ADDENDUM NO. 1

DATE OF ISSUANCE: July 24, 2026

PROJECT: City of New Albany Maryland Ave. Community Center
2020 Maryland Ave.
New Albany, IN 47150

ARCHITECT'S PROJECT NO.: 25-512.000

NATURAL GAS RISER "B"
NO SCALE

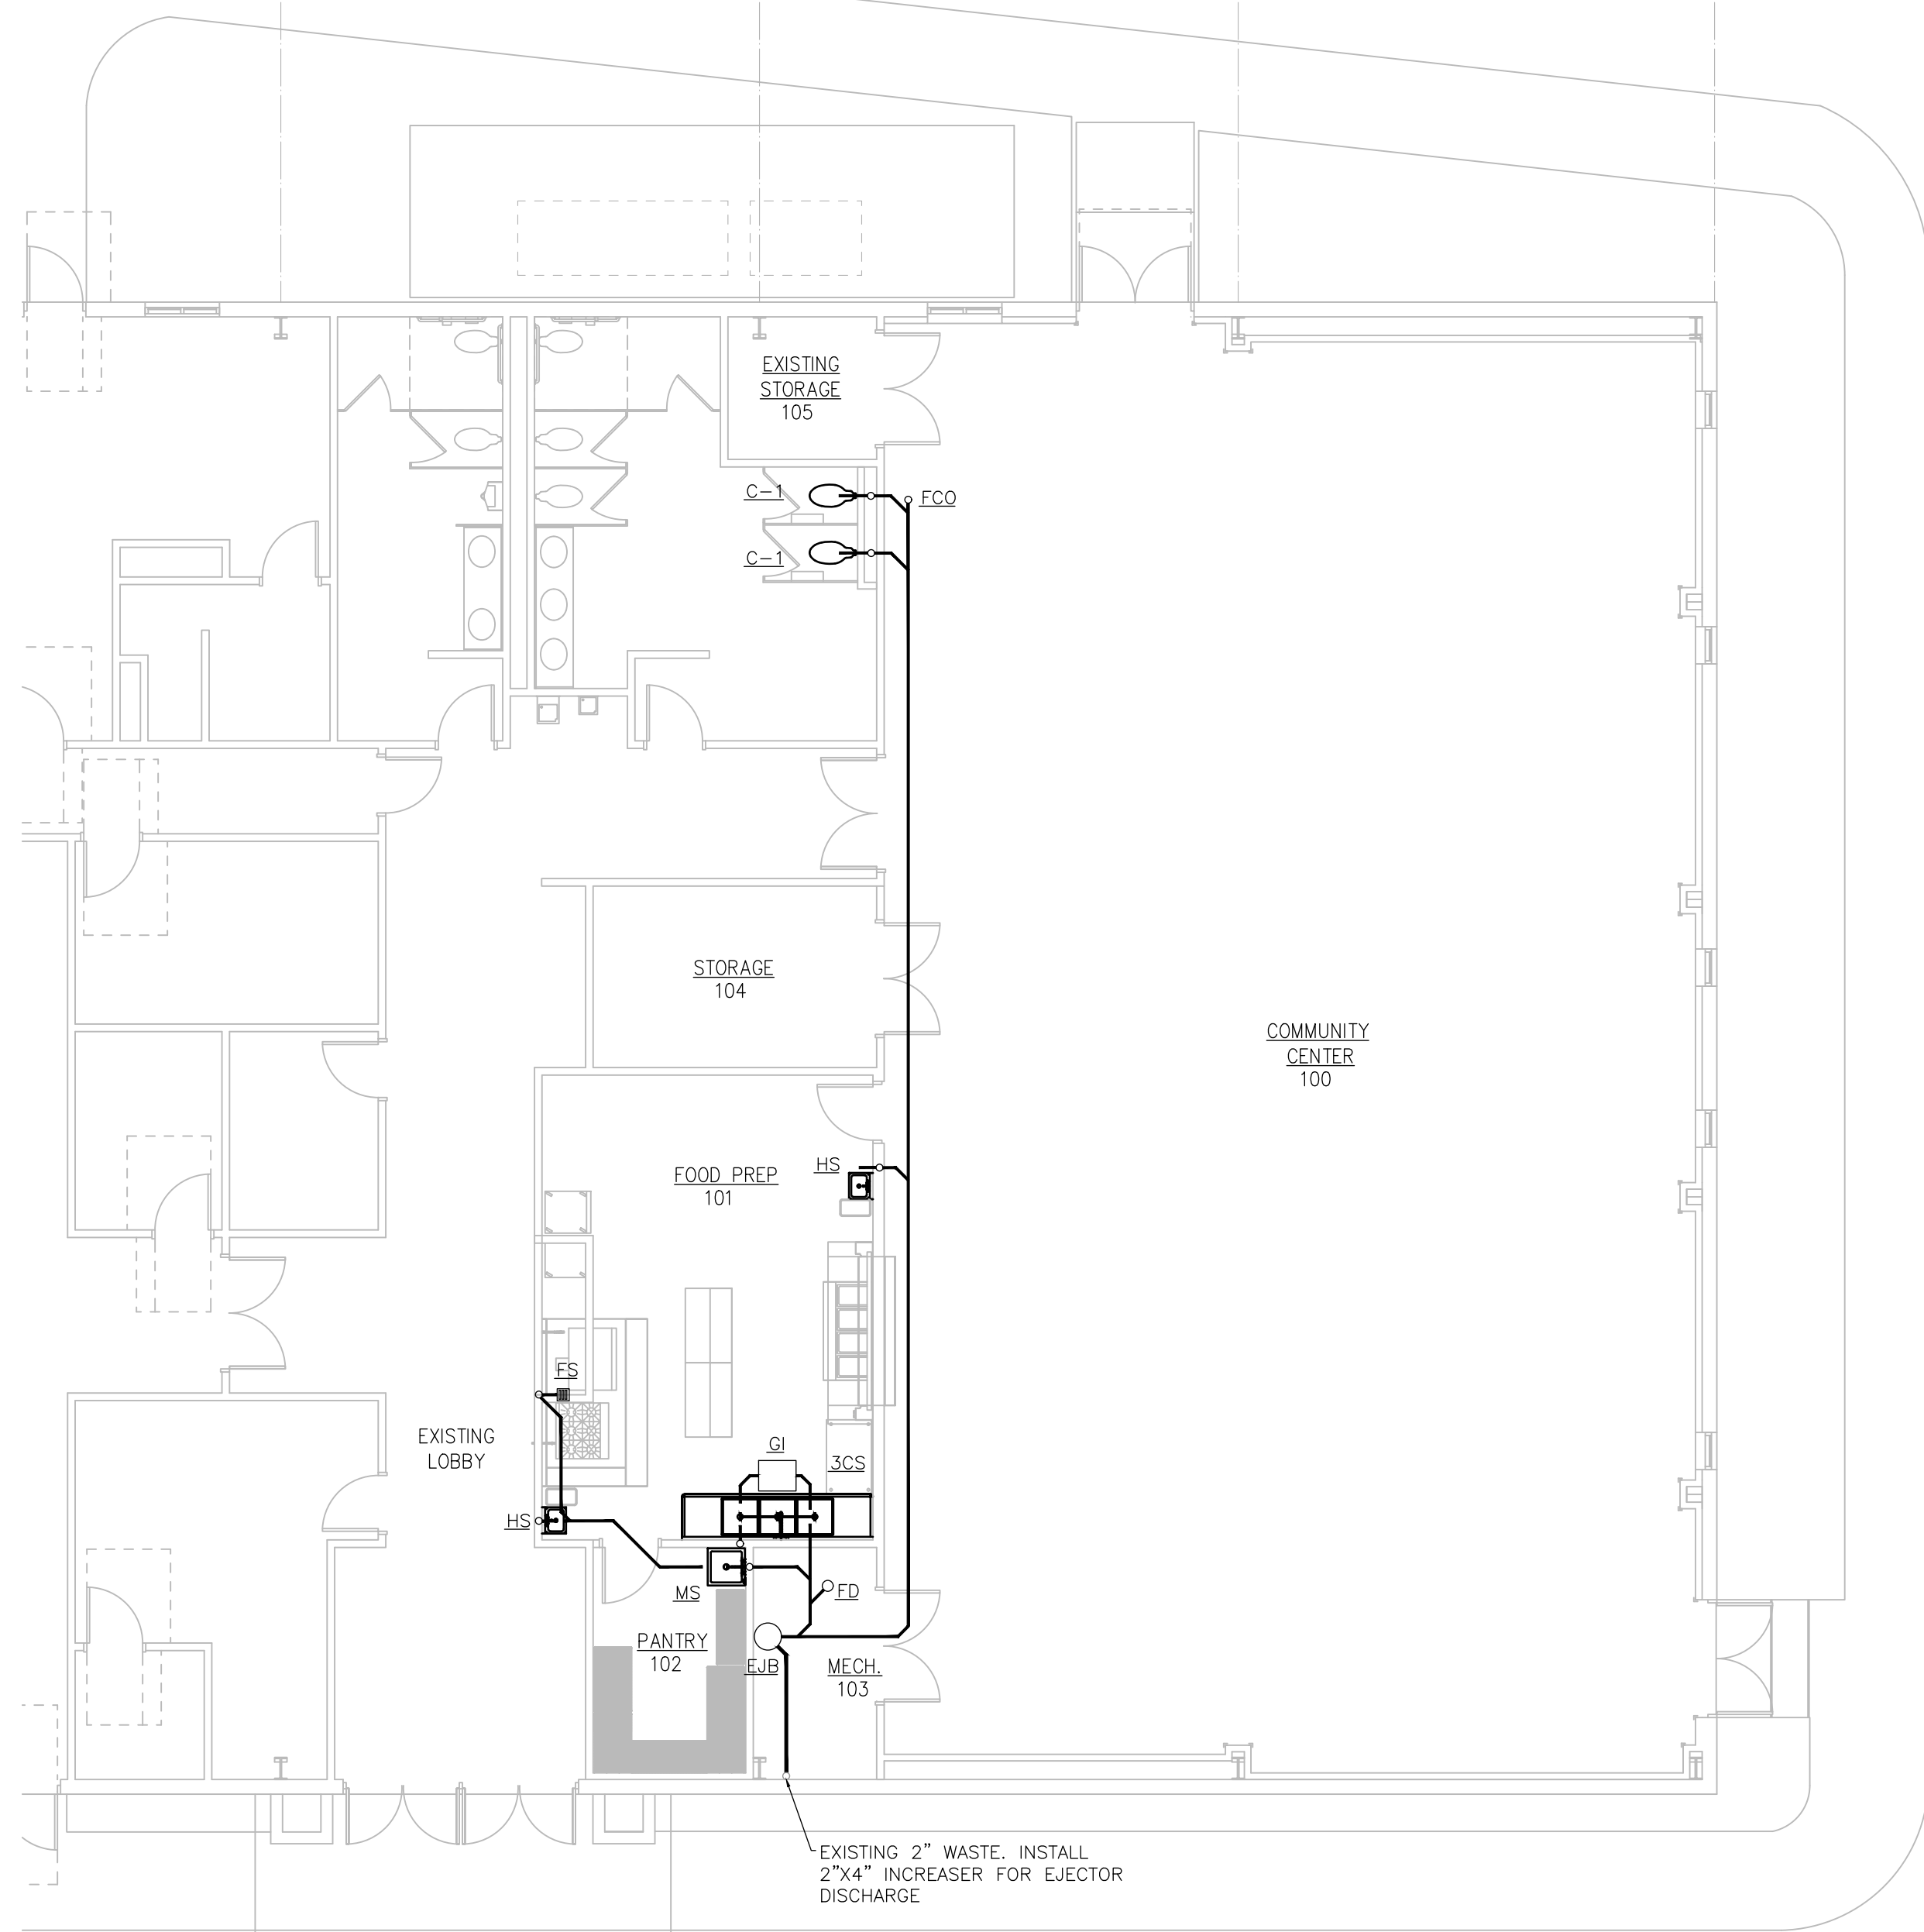
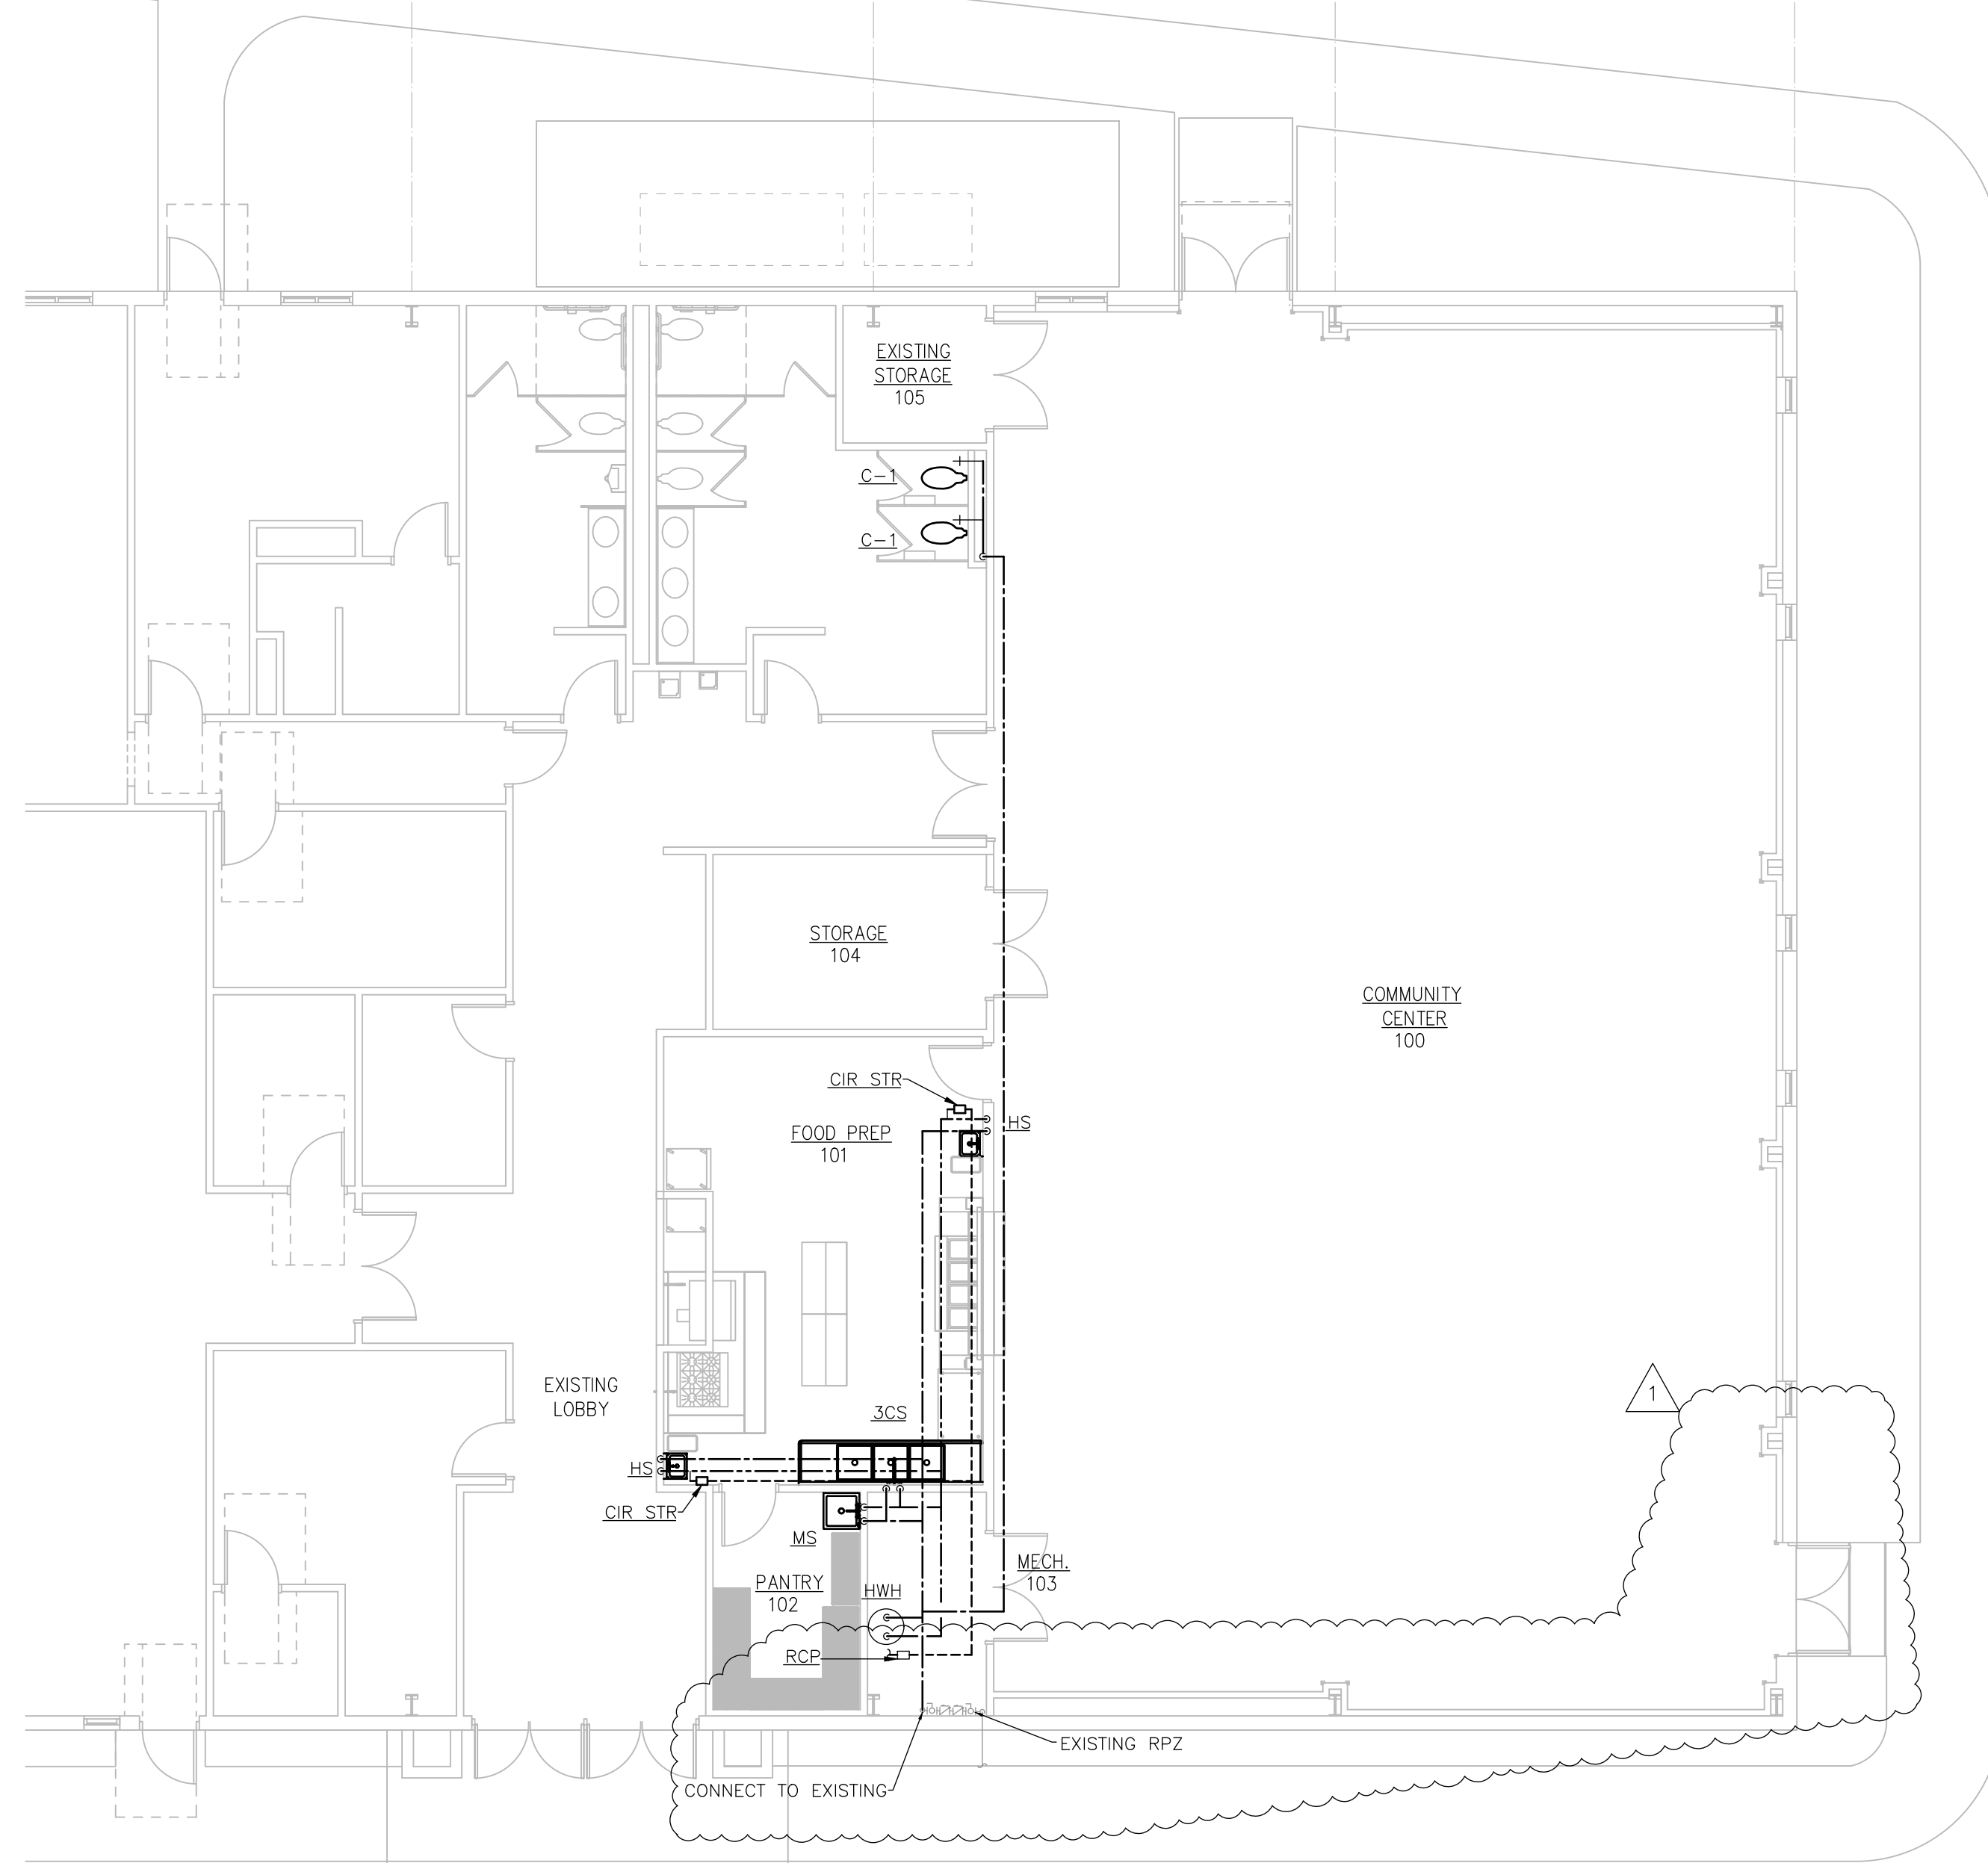
ADD-1 Item No. D-4 - Revised Existing Backflow Preventer Location

Sheets P 001 and P 101 dated 07/23/2026 have been revised to accurately represent the location of the existing backflow preventer in both plan and domestic water riser diagram.
